**Our Ref: 217510\_LET\_001A**

**QUORN PARK SOLAR FARM (SSD 9097)– AMENDMENT REPORT****Construction Water**

## Attachment 2 Indicative dimensions for buildings

# PROPOSED CONTROL ROOM BUILDING

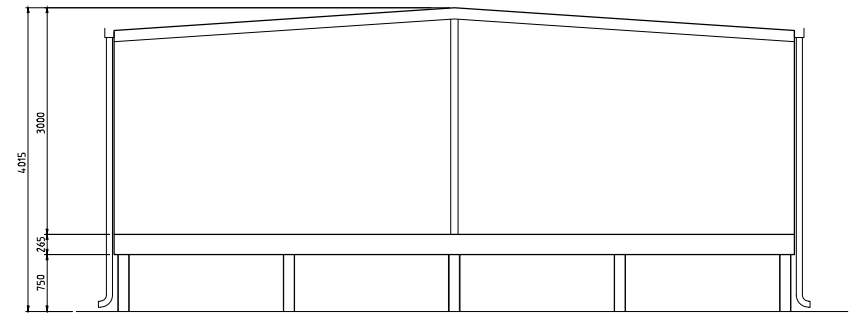
The control room building is now proposed to be 17.5 m wide x 9.0 m deep x 4.5m high. This is a larger building than that identified in the EIS (5 m wide x 3.5 m deep x 2.7 m high). It is also now proposed to include an operations and maintenance shed that would be 18 m wide x 12 m deep x 7 m high. Indicative floor plans and elevations are provided as **Attachment 2**.

The larger control building and the new operations and maintenance shed will not materially increase impacts on receivers. Both buildings will be constructed using non-reflective finishes and would be located no closer than 1,458 m from any resident.

The control building and operations and maintenance shed would be constructed of materials designed to effectively integrate with the rural environment, including using non-reflective materials and muted tones. This is consistent with existing buildings on site and with other rural buildings in the surrounding locality.

The scale and height of the control building is consistent with the character of residential and non-residential buildings in the locality. It is also consistent with the proposed height of the solar infrastructure.

# PROPOSED OPERATIONS AND MAINTENANCE SHED

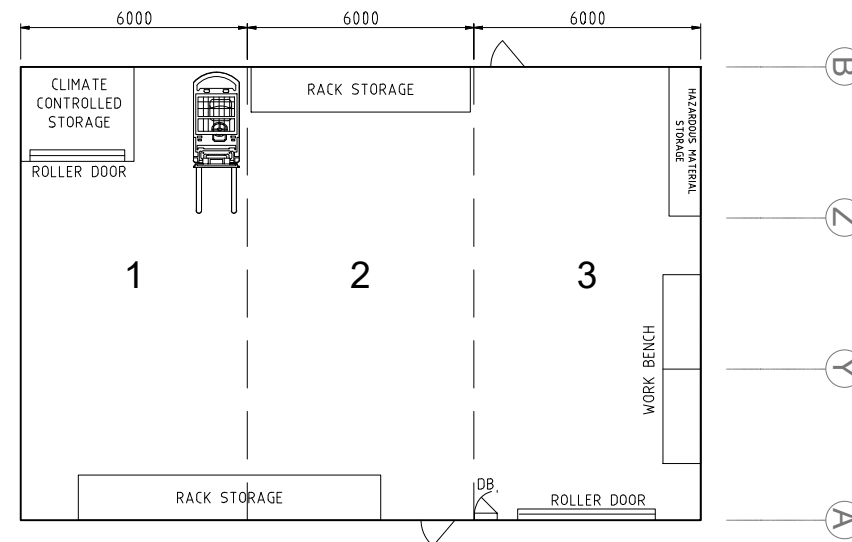
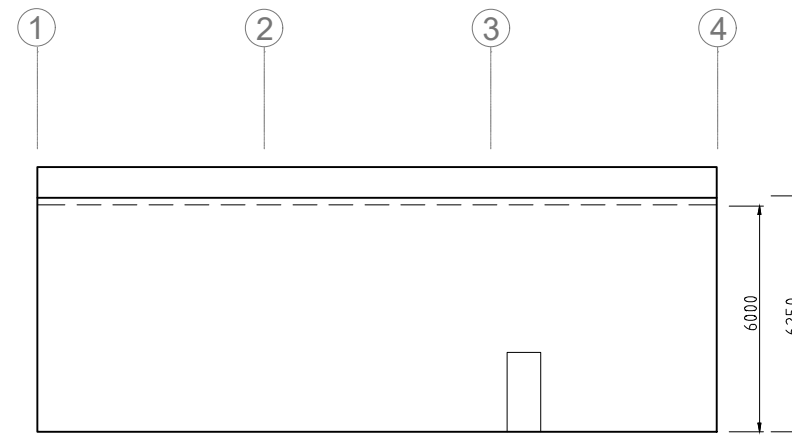
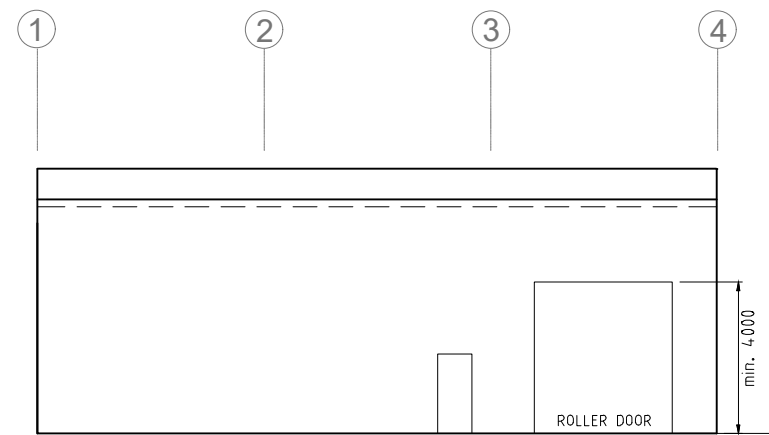
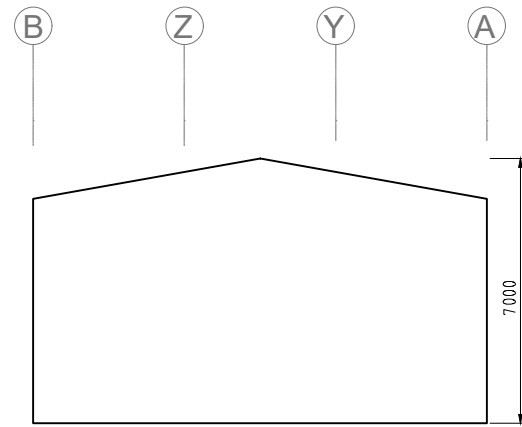
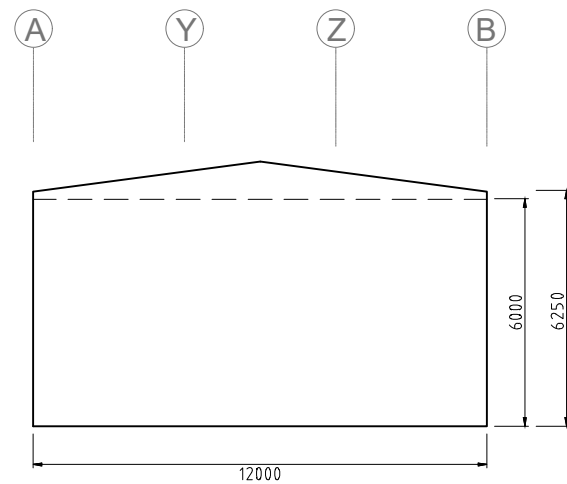
Similarly, the scale and height of the operations and maintenance shed is in keeping with the rural character, noting that sheds of a similar or greater size and height (up to 10 metres in height and 2,000 m<sup>2</sup> in size) may be constructed in the RU1 zone as exempt development (that is, without recourse to Council or a certifier). This confirms the suitability of these buildings.
